Template for comments

Date: 24 July 2015	Document: CDM-MP67-A20 Information Note: Analysis and proposals on the revision of “Tool to calculate emission factor of electricity system”
---------------------------	--

Name of submitter: Daniel Rossetto

Affiliated organization of the submitter (if any): Climate Mundial Limited

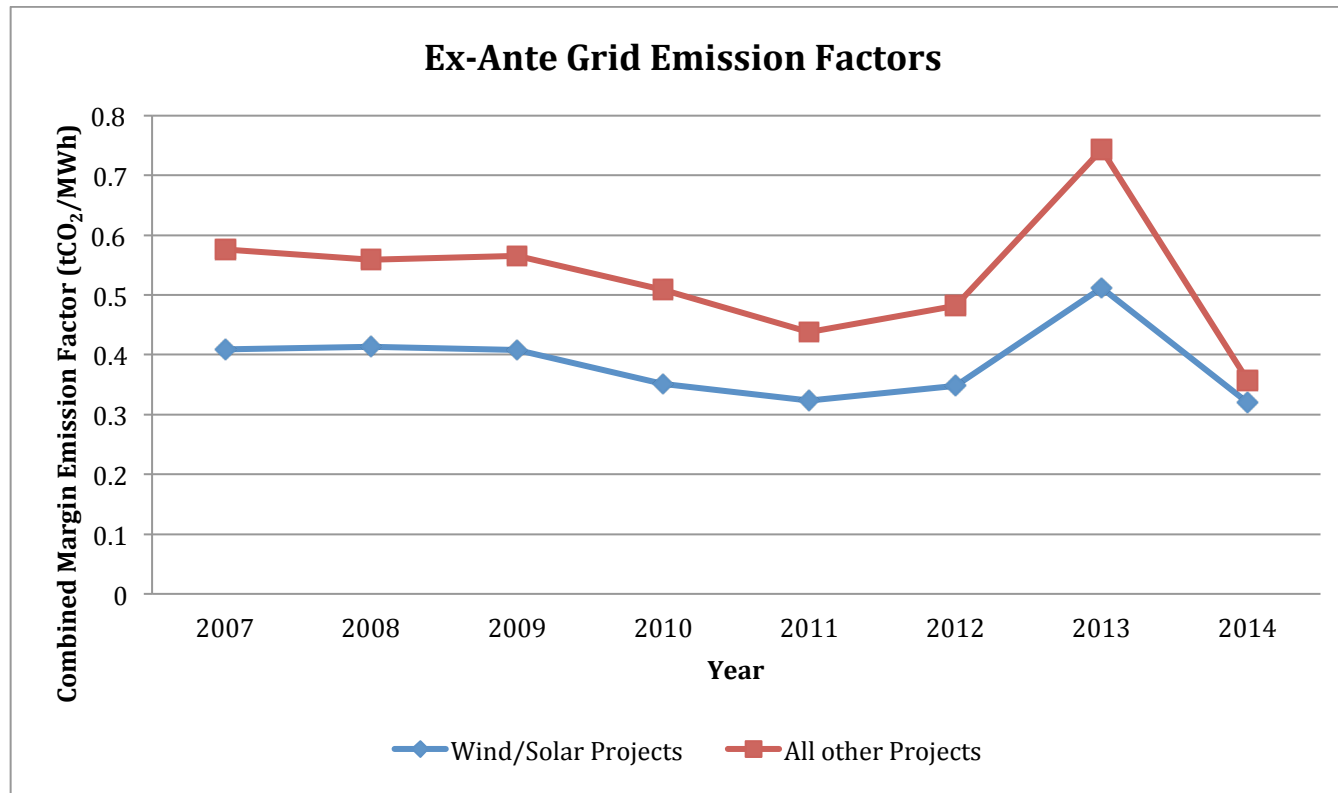
Paragraph 10	General	Technical	The use of three-year averages leaves grid emissions factors particularly vulnerable to large swings in the operating margin from year to year. As the attached data supplied by the Ghanaian national authority shows, a large amount of gas-fired generation dispatched in 2014 has brought down the emissions coefficient by more than 50% in one year even though it is based on three-year average. This is exceptionally penalizing to new renewable energy projects in that country wishing to set the grid emissions factor on an ex ante basis.	In addition to the other reforms discussed in this paper, the CDM Executive Board should consider allowing project participants to work with national authorities to select larger data sets (beyond three years) for the purposes of calculating the operating margin.

Data supplied courtesy of the Energy Commission of Ghana

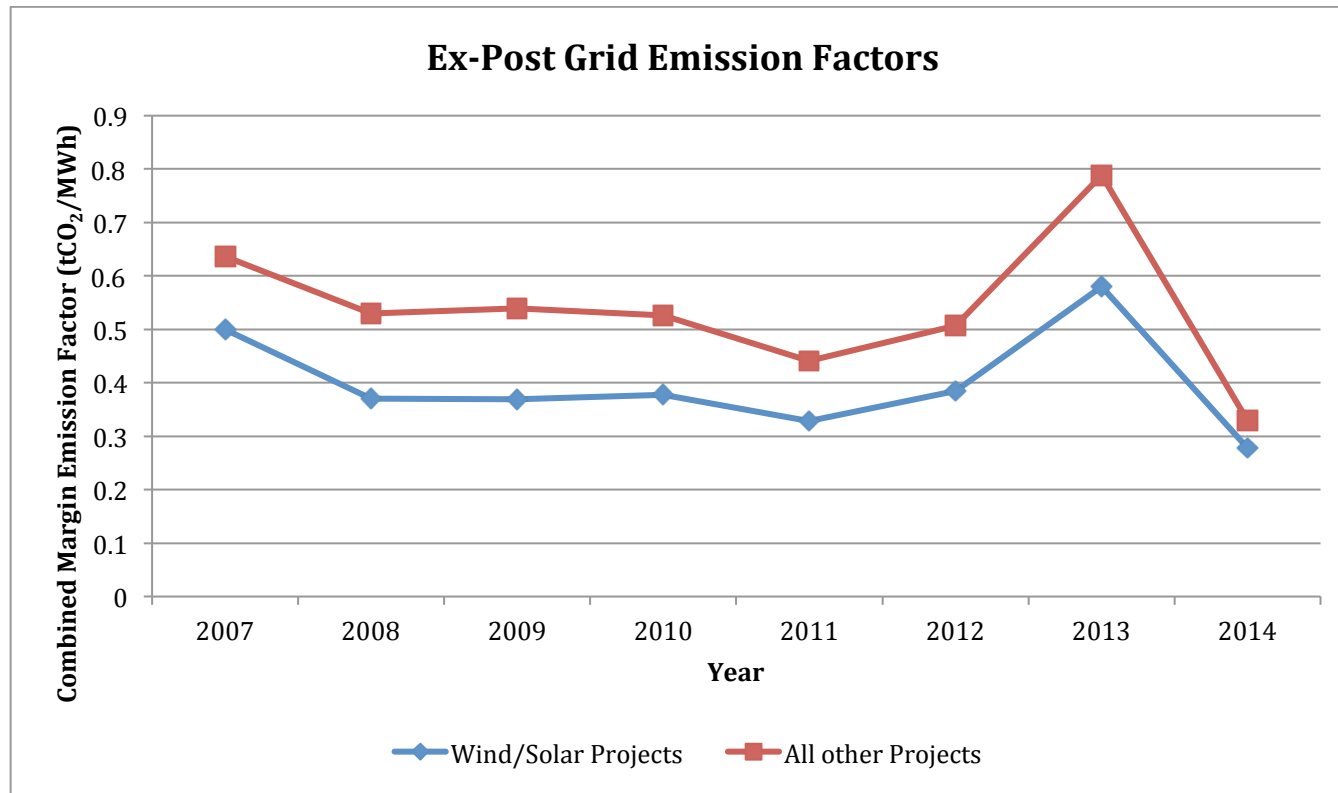
Paragraph 21	None	Technical	<p>It is absolutely clear that in many developing countries – particularly those in West Africa - there has been a proliferation of embedded generation running on diesel by individual power users. This generation serves as a means of increasing the reliability of their supply in the context of blackouts, which could be avoided altogether if there were more large-scale renewable energy generation installed in the countries concerned. Data on these embedded generators is, however, generally not available to Governments. Therefore it cannot be included in the build margin calculations as they stand.</p>	The CDM Executive Board should consider allowing project participants to make an assumption – in consultation with the host country government – about the penetration of diesel-fuelled embedded generation within the build margin calculations.
